BLAISE AD HAZOP

RMD-02-004

An interface HAZOP study was undertaken at BioConstruct's offices at Stockton-on-Tees, Teesside on 3rd June 2019, commencing on 4th June and being completed on 9th July, on the design of the proposed Anaerobic Digestion Facility for Crofthead.

This report details the findings of the HAZOP Study. The drawings used in the HAZOP study are found in the Drawings Section of this report and are based upon the following P&IDs:

Node 2

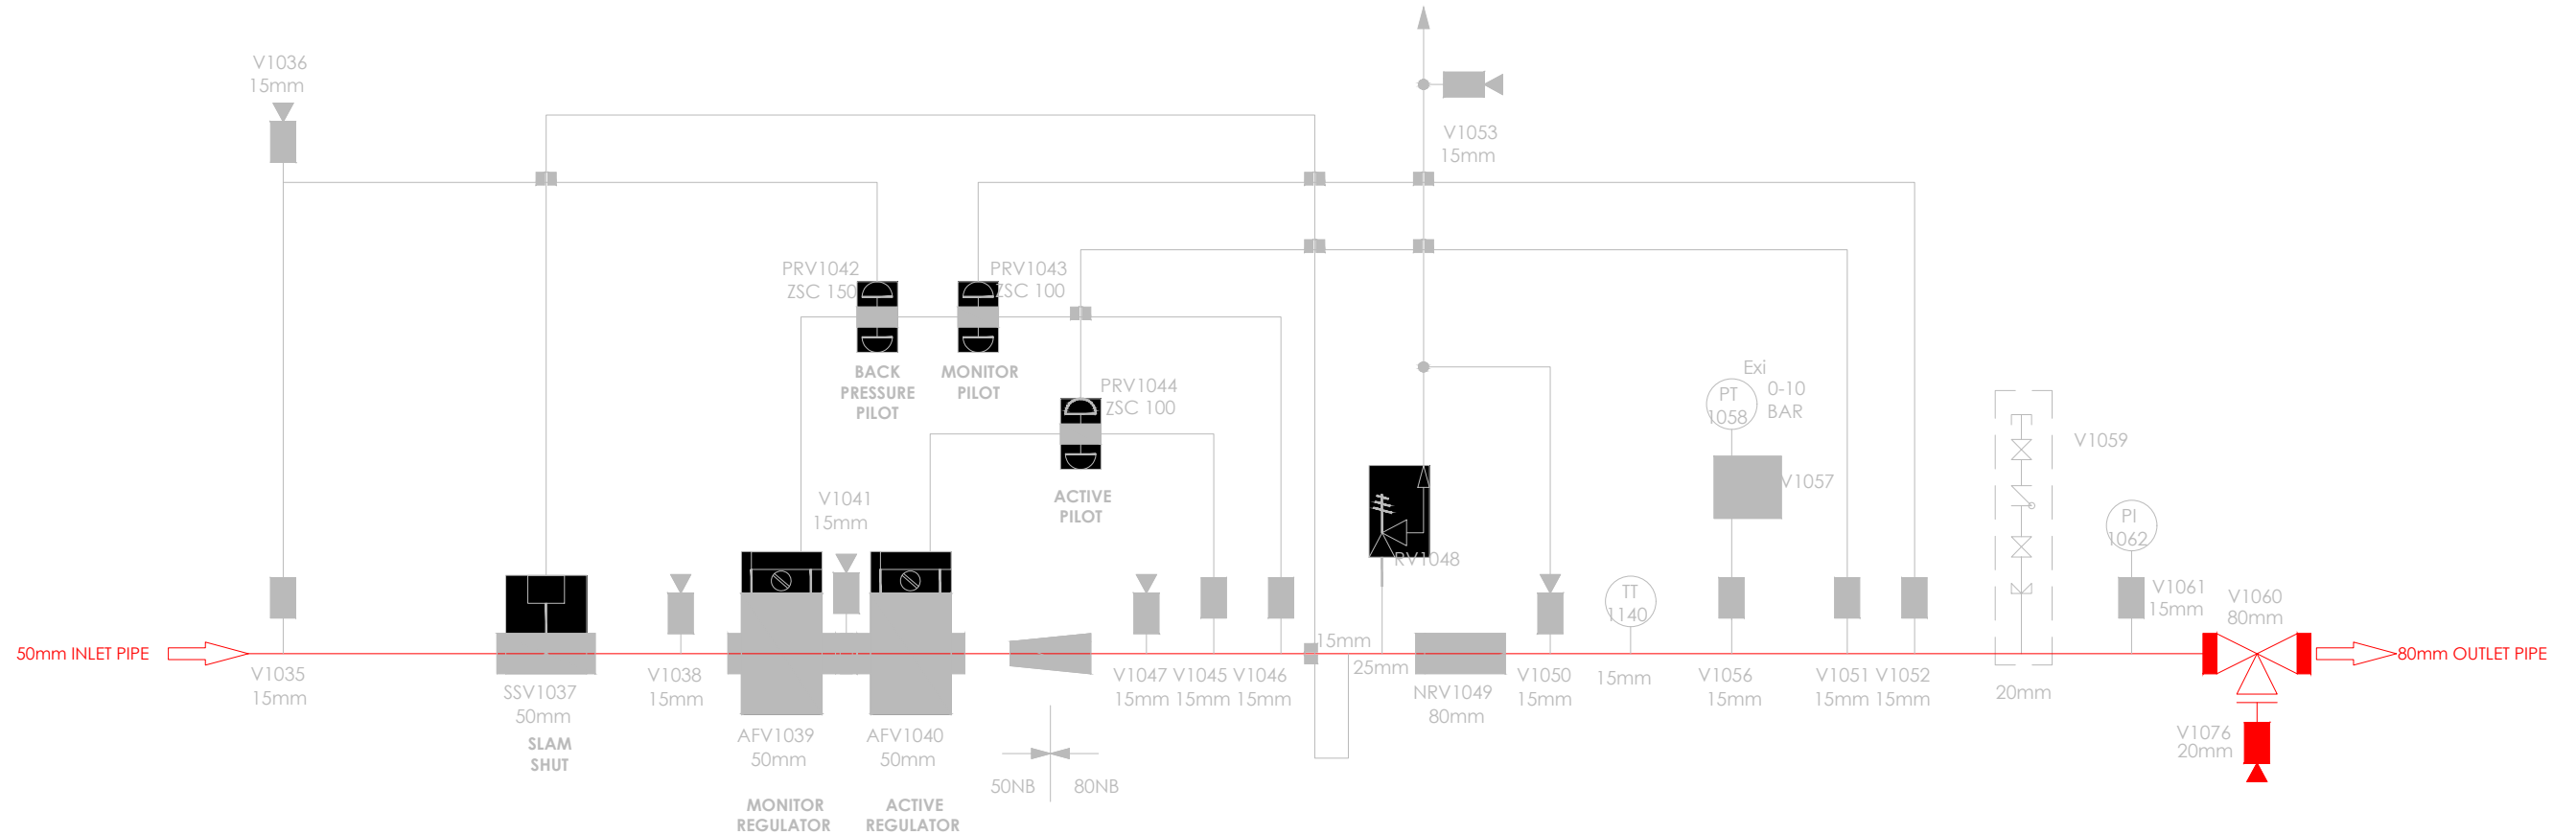
| ID/No. | Deviation | | No. | Possible Causes | Consequence | Safeguards | No. | Actions Required | Action Allocated to |
|--------|------------|-----------|-------|---|--|--|-----|------------------|---------------------|
| 2.1 | No | Flow | 2.1.1 | Poor biomethane quality | <ul style="list-style-type: none"> The Elster unit goes to reject to flare - 20 minute reject to allow gas quality to improve, inefficient operation | <ul style="list-style-type: none"> Gas analysis in the AD facility to monitor gas quality fed to BUU BUU CH4 measurement to ensure correct purity fed to Elster unit Realtime monitoring of biomethane quality within Elster unit allows adjustment of propane to maintain CV OFGEM analyser on outlet measures full biomethane quality | | | |
| | | | 2.1.2 | The ROV is shut | <ul style="list-style-type: none"> The Elster unit will reject to flare After 20 minutes a "not available" signal sent to Elster to Pentair - Pentair unit shuts down and bleeds back to the AD biogas line to relieve pressure - approximately 2 hours gas storage buffer within the AD facility at normal operation Potential flaring of biogas | <ul style="list-style-type: none"> Poor gas quality (see 2.1.1) Loss of communications (see 2.1.3) | | | |
| | | | 2.1.3 | Loss of communications | <ul style="list-style-type: none"> Closure of ROV and reject to flare (see 2.1.1 & 2.1.2) | <ul style="list-style-type: none"> 2 methods of communication, satellite link and backup telephone line - 4 minute lag to allow either satellite link to be restored or telephone line communication to synchronise | | | |
| | | | 2.1.4 | Interference damage on grid | <ul style="list-style-type: none"> Inability to inject to grid requiring divert to flare If catastrophic damage to gas main ROV will operate and reject to flare from Elster unit | <ul style="list-style-type: none"> A valve chamber available to SGN engineers to allow fitting of a valve rider governor which can be fitted to facilitate pressure reduction | | | |
| | | | 2.1.5 | Loss of propane | <ul style="list-style-type: none"> Biomethane quality unable to meet CV target - unable to inject to grid (see 2.1.1) See Node 4 | <ul style="list-style-type: none"> See Node 4 See 2.1.1 | | | |
| | | | 2.1.6 | High inject differential pressure compared with grid pressure | <ul style="list-style-type: none"> Unlikely scenario | | | | |
| | | | 2.1.7 | No flow from BUU | <ul style="list-style-type: none"> Inability to inject to grid (see Node 1) | <ul style="list-style-type: none"> See Node 1 | | | |
| | | | 2.1.8 | Power failure (including lightning strike) | <ul style="list-style-type: none"> Unable to inject gas to grid thus reject to flare approximately 2 hours gas storage space in normal operation before requirement to reduce pressure through flaring | <ul style="list-style-type: none"> Battery pack capable of maintaining 8 hours instrument life for SGN RTU (remote telemetry unit) 2 hour battery pack for controlled shutdown of grid entry unit Battery pack for Coms and instrumentation within AD facility Automatic start-up of backup generator on AD facility to maintain critical plant and equipment including the flare Lightning risk assessment (see DSEAR assessment) | | | |

| ID/No. | Deviation | | No. | Possible Causes | Consequence | Safeguards | No. | Actions Required | Action Allocated to |
|--------|------------|-----------|--------|---|---|--|-----|------------------|---------------------|
| 2.1 | No | Flow | 2.1.9 | Failure of LGT (odour unit) | <ul style="list-style-type: none"> Potential to inject un-odorised gas into network - not GSMR compliant | <ul style="list-style-type: none"> Low level alarm on the odorant, alerts operator to refill - operator decants to onboard reserve tank and new bottle ordered for delivery(approximately 7-10 days minimum capacity within reserve tank) Flow meter measures odorant injection Measure odorant injection pump strokes and calculate flow - if pump strokes or flow measurement inconsistent then alarm and send to divert | | | |
| | | | 2.1.10 | Biomethane temperature outside specified range in NEA (0-20 degrees maximum) On start-up high or low ambient temperature Failure of Pentair chiller | <ul style="list-style-type: none"> Inability to inject to grid - divert to flare Potential damage to gas main | <ul style="list-style-type: none"> Temperature measurement within Elster unit TT1023 ensures high temperature or low temperature biomethane is diverted Temperature measurement from TT1140 ensures temperature to grid within specification and diverts when outwith specification 10 minute period granted by SGN on start-up to allow temperature to fall within range | | | |
| | | | 2.1.11 | Compressed air failure | <ul style="list-style-type: none"> Inability to operate valves - potential unsafe scenarios, increased fire and explosion risk | <ul style="list-style-type: none"> Compressor reservoir allows sufficient capacity to shutdown plant in a controlled manor Valve to reject fails open ROV and gas to grid valve fail closed Propane valve fails closed Low pressure switch in Pentair compressor alarms Potential to connect to BioConstruct compressed air system if required | | | |
